To: Natural Resources Wales
From: Jen McMillan
Date: 25 February 2020
Copy: James Orme, Graham Morley
Our reference: PB5034-RHD-ZZ-XX-NT-Z-1000
Classification: Project related

Subject: Updated assessments for terrestrial ecology (excluding chough) in response to comments made on the Environmental Statement by NRW and RSPB: draft for discussion in meeting schedules 28/2/2020

Figure 1 – Option A selected as trenching route

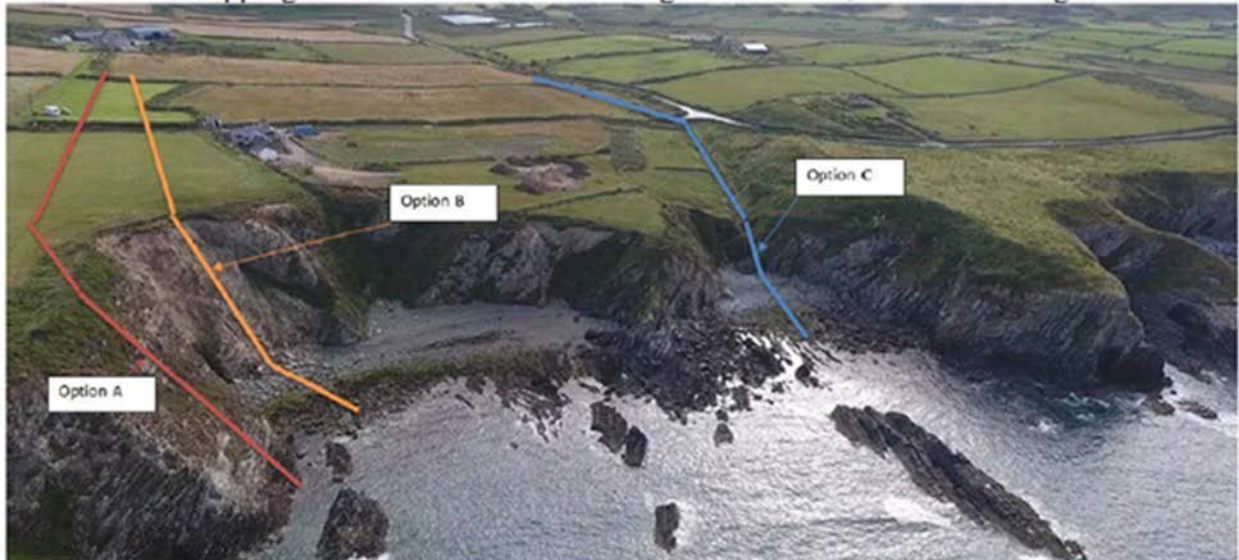
Comment Number	Comment Detail	Morlais Response
7	Paragraph 218 refers to cables being temporarily pinned to the cliff if HDD is not possible. However, if this is for the duration of the project, i.e. 37 years, NRW Advisory considers this to be a permanent impact (as defined in Table 5-5 of the ES, Volume I), rather than 'temporary'. The same paragraph refers to reinstatement of temporarily lost or disturbed habitat. If the same interpretation of 'temporary' is used reinstatement may not occur until after the end of the project, which NRW Advisory cannot agree with.	Assessment updated in Section 6 of this document and includes for permanent impacts
8	Paragraph 219: Considering that the trench is described as up to 10m wide with a 30m wide working corridor, turf storage would be expected to take up a 10m wide strip leaving just 10m of the 30m wide working corridor for vehicle movements and soil storage etc. NRW Advisory is therefore concerned as to whether the proposed turf reinstatement method would be workable. As a minimum there should be a temporary fence preventing vehicles driving on the edge of the stored turf. Turf would need watering in windy weather as well as dry.	Locations shown on Drawing 2 (Ref: 122938-BVL-Z0-00-DR-Z-00003) and methodology discussed in Section 5 Assessment updated in Section 6 of this document

The route of the cable line would follow Option A (denoted by the red line) shown in Figure 1 below. Drawings 1 and 2 also provide further details on the design and layout of the preferred and secondary options for landfall at the cliff.

Option A traverses a sea cliff inclined at about 45 degrees with alternating beds of sandstone and mudstone dipping into the cliff at about 50 degrees to North, as shown in Figure 1.

Drawing title
**LANDFALL
TRENCH CABLE OPTION
CLIFF FACE ATTACHMENT**

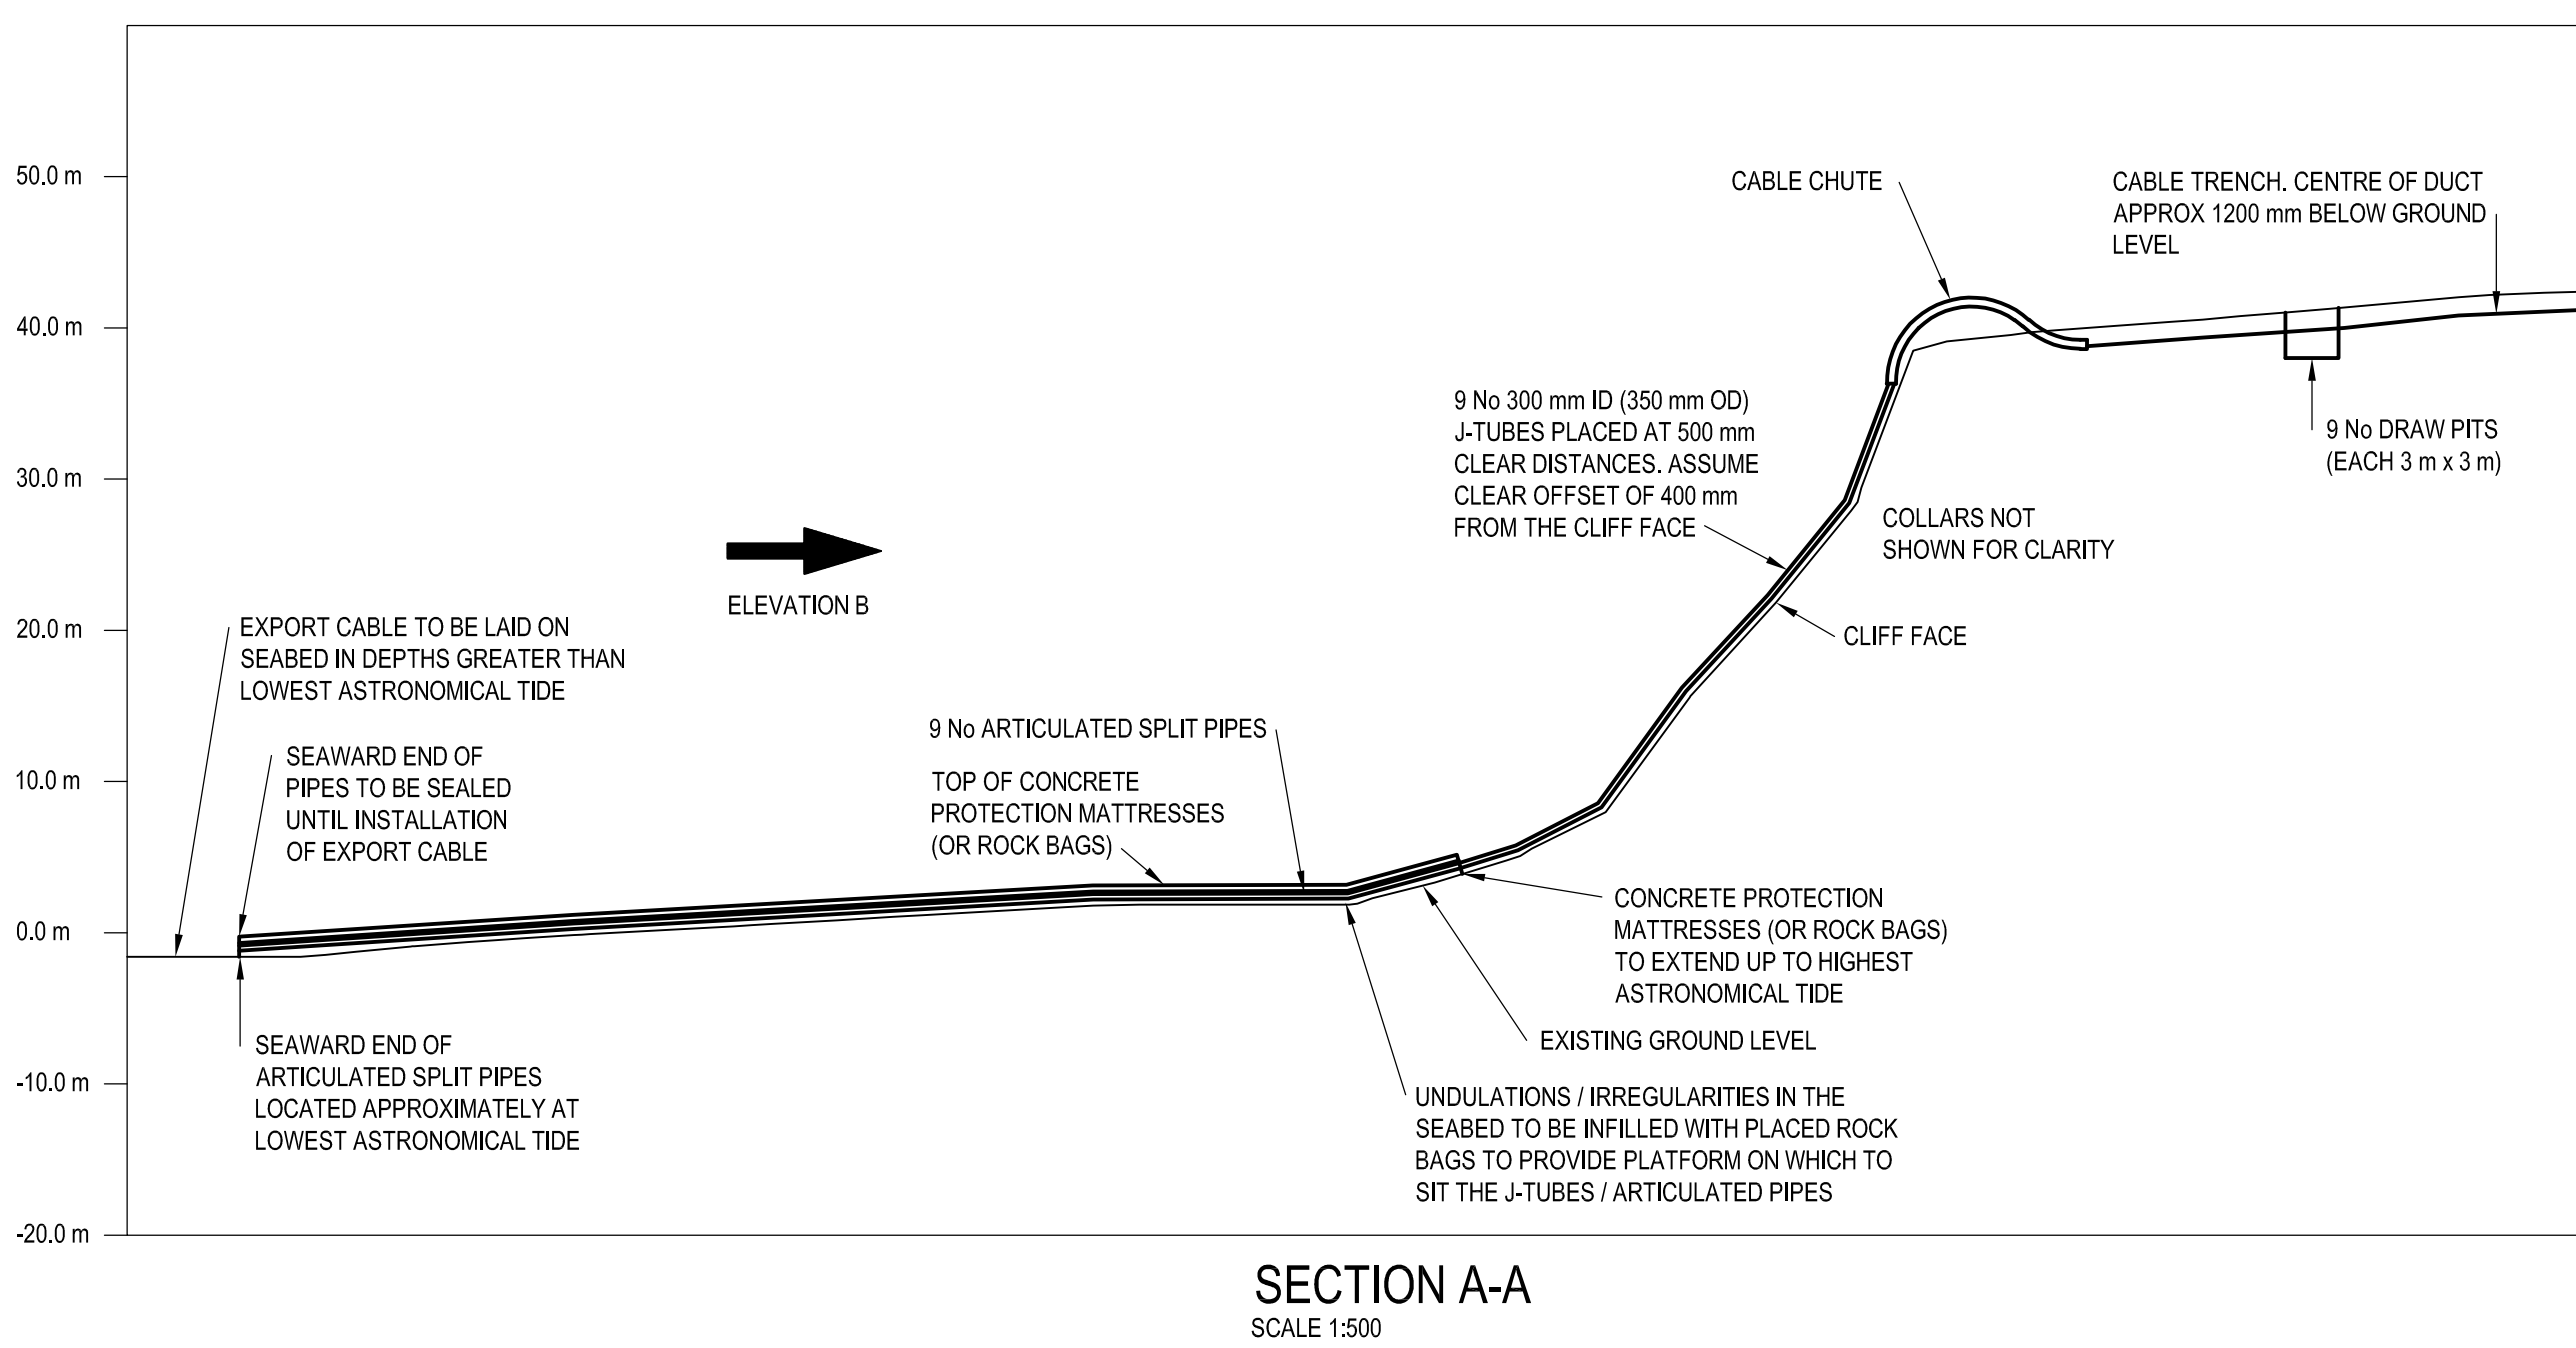
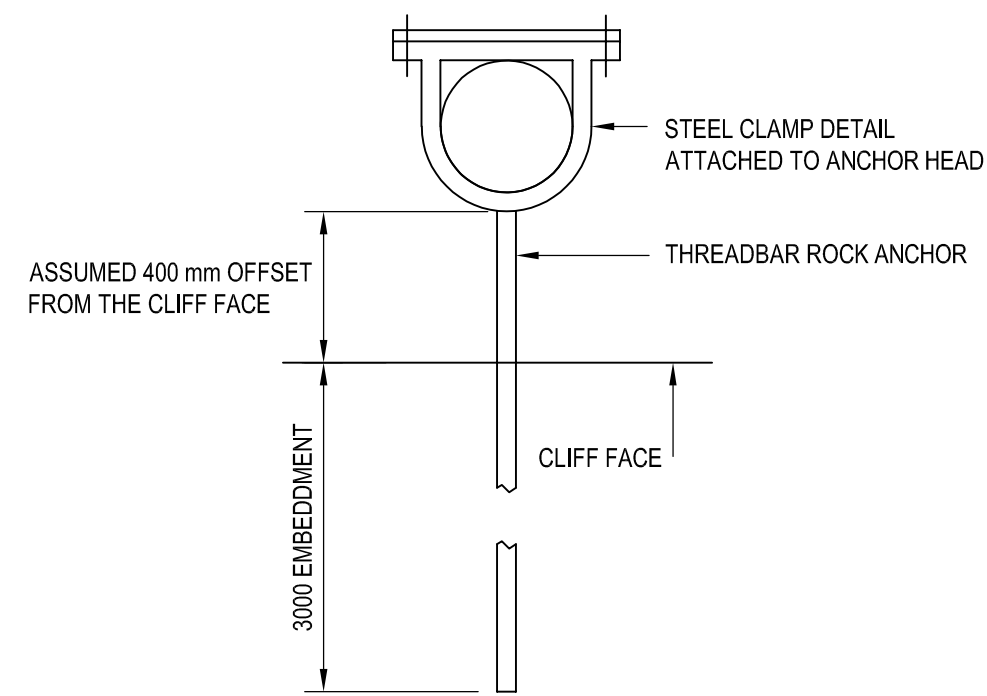
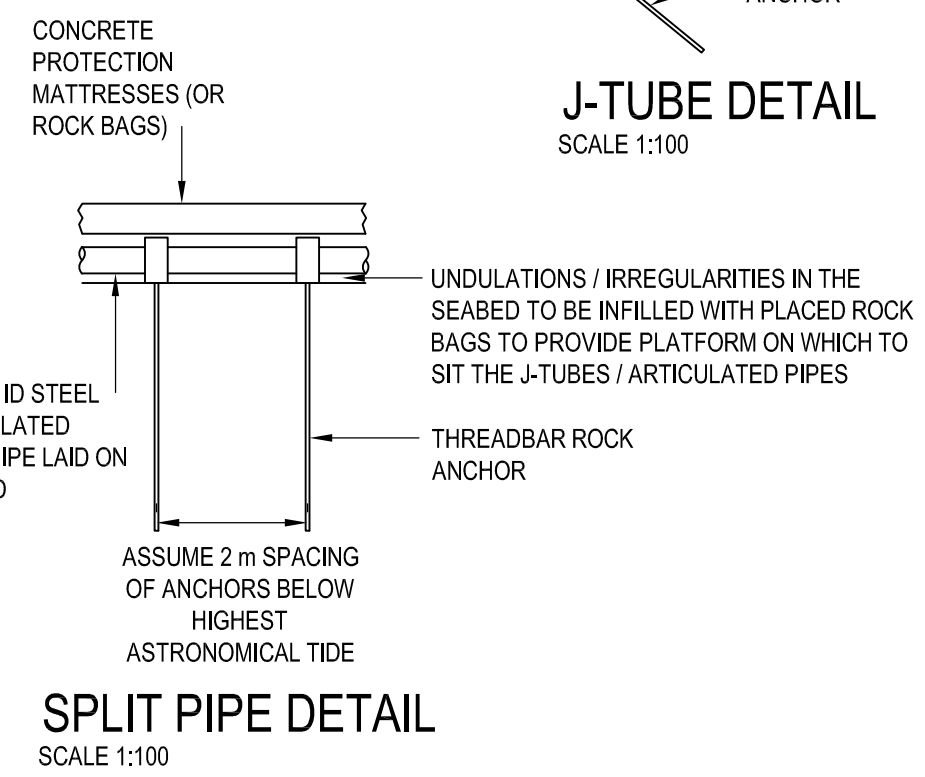
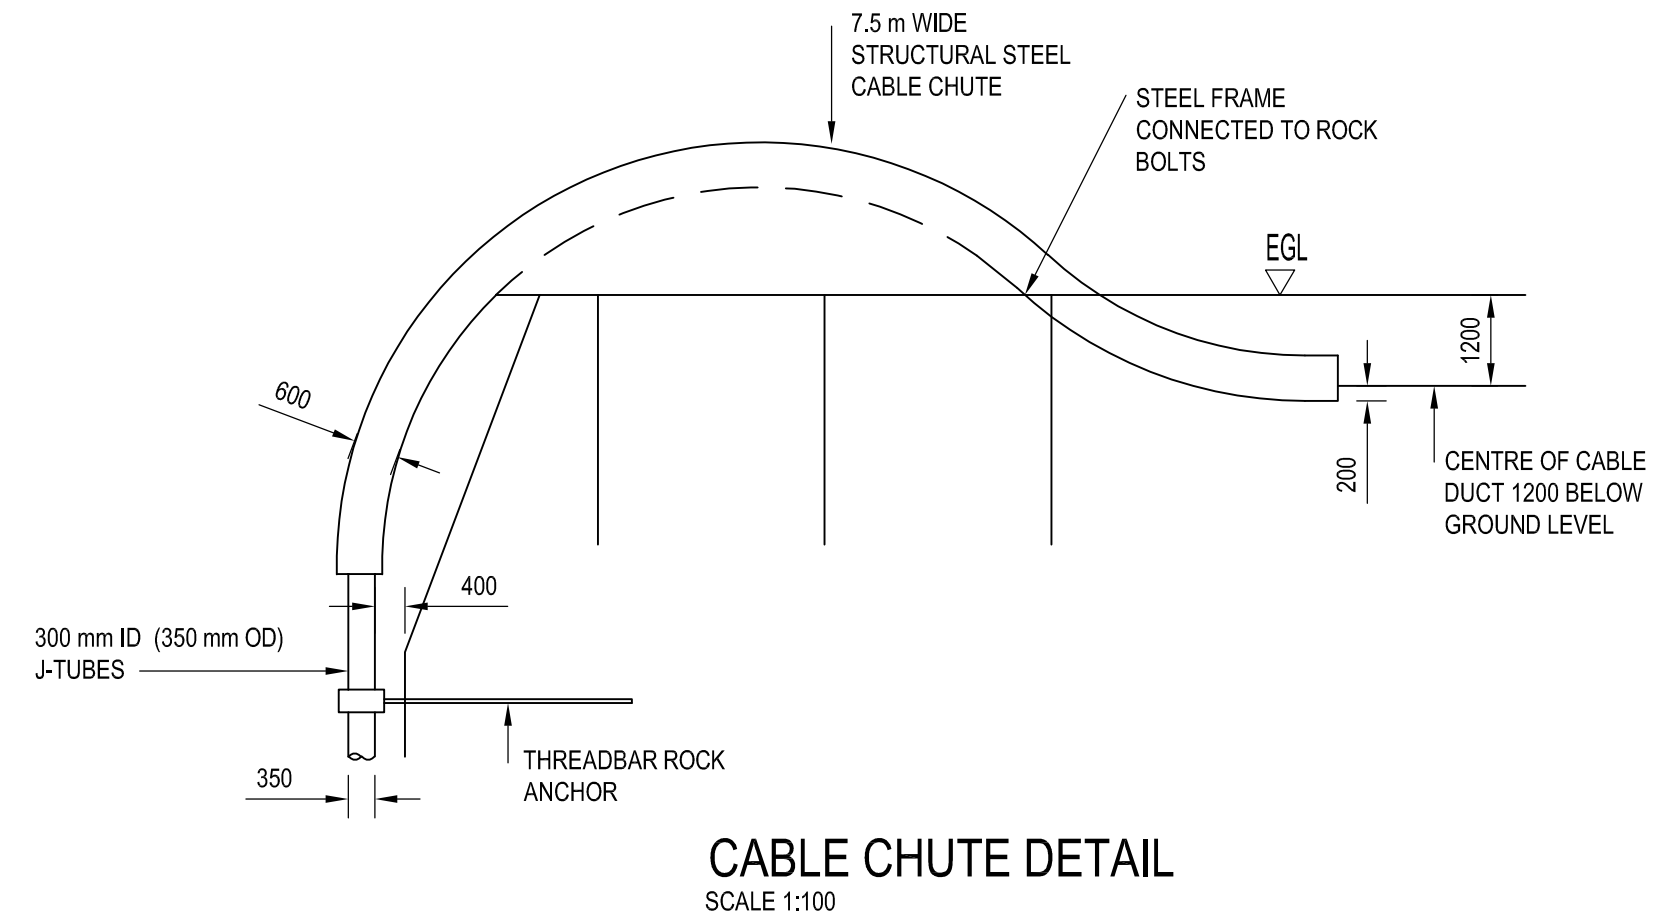
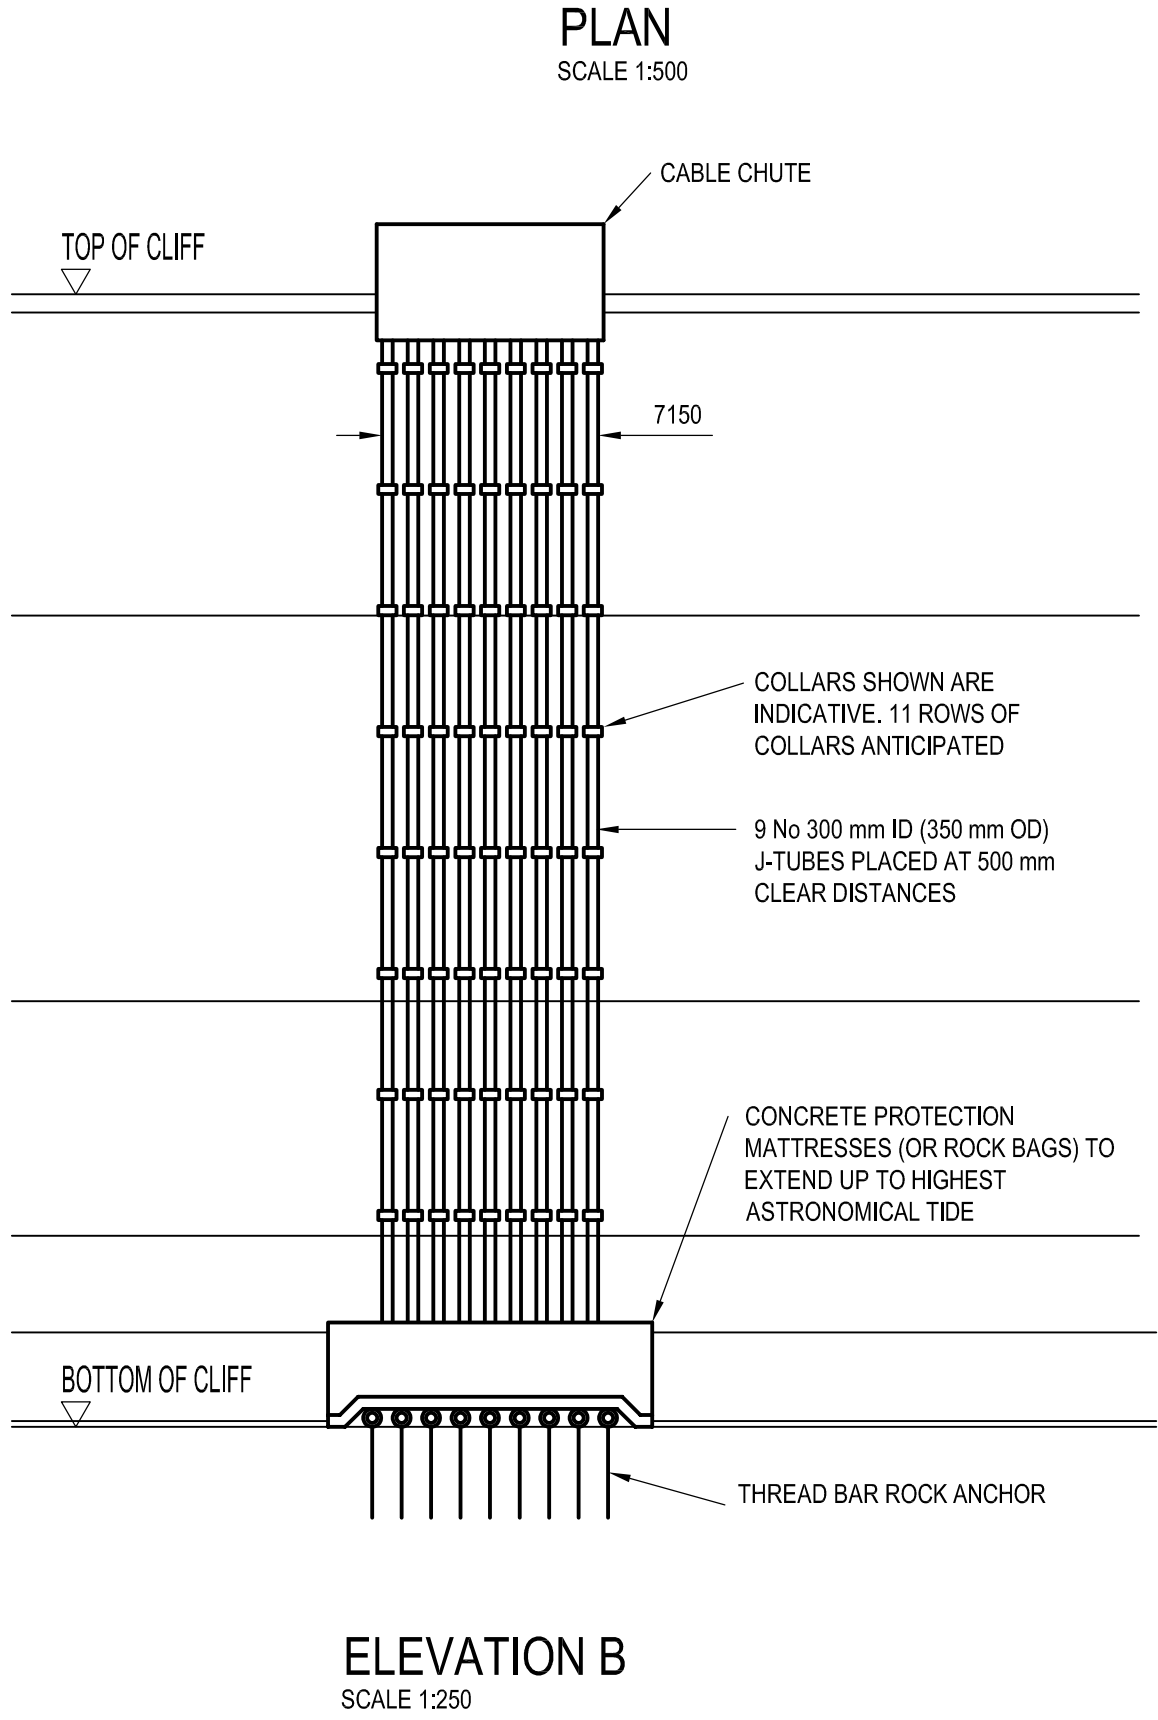
Comment Number	Comment Detail	Morlais Response
	clarification on how shallow slots would be cut into the cliff and how this would be done without major permanent damage to the SAC feature.	
22	NRW Advisory disagrees with the conclusions regarding the impact on the Holy Island Coast SAC because calculations of the potential impact on the SAC are based on the percentage of the whole SAC area rather than the area covered by the designated feature i.e. vegetated sea cliff.	Assessment updated in Section 6 of this document including updating the percentages based on the feature
23	NRW Advisory disagrees that habitat loss associated with the worst-case open trenching method (if required) would be temporary; we consider that some at least will last for longer than the 37-year operational period and hence could be considered permanent (as defined in Table 5-5 of the ES, Volume I).	Assessment updated in Section 6 of this document including for permanent impacts

This section should be read alongside Drawing 1: 122938-BVL-Z0-00-DR-C-00600.P02-S2.

From the draw pits, the cable ducts will be marshalled closer together on approach to a structural steel cable chute positioned at the edge of the cliff. This length of cabling is anticipated to be installed using similar excavation equipment as per the main cable trenching works with the 32m working maintained to provide flexibility to complete the cliff side pinning works. Storage of turf (where practicable), top soil and excavated material will adopt the stockpile area used for the main trenching works which is in an area of Low Sensitive Habitat. The total excavated area of the cable trench between the draw pits and cable chute is c.191m² and will take approximately 1 week to complete (subject to production rates).

The thread bar anchors penetrate 3m into the rock, and will provide support the rock face of the cliff. Any maintenance of the J-tubes within the SAC is considered to be infrequent. In the unlikely event maintenance is required on the cliff face (i.e. within the SAC) the approach would be similar to construction, i.e. using a crane at the top of the cliff to support a lowered platform. As a worst case, the footprints and dimensions would be the same as per construction. It is likely that inspections of the J-Tubes would take place every 5 years and following severe storm events.
